29 October 2020

Our Ref: HSK:AUT003/4006

Objection to Proposed waste collection, treatment and disposal Facility (SSD 10396) at 23-43 and 45 Tattersall Road, Kings Park NSW 2148

Figure 1: Comparison of windrose plots

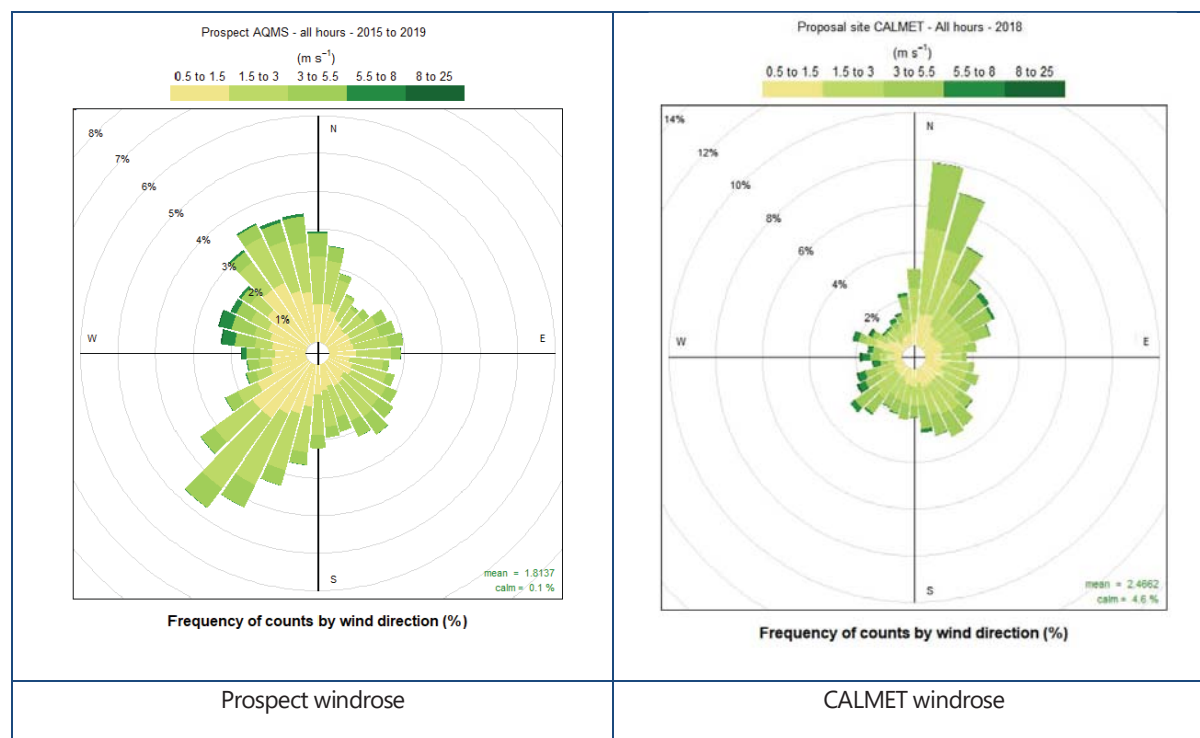
The windrose generated from CALMET for the site has a significantly different annual wind distribution than that of measured observation data for Prospect, as seen in **Figure 1**. The Prospect windrose shows a predominance of winds from the southwest and north-northwest and generally a low percentage of winds from the northeast quadrant whereas the CALMET windrose shows predominant winds from the north-

northeast and few winds from the southwest and north-northwest. The appropriateness/representativeness of the meteorological modelling used in the assessment needs to be justified to determine if the modelling is adequately representative of the locality.
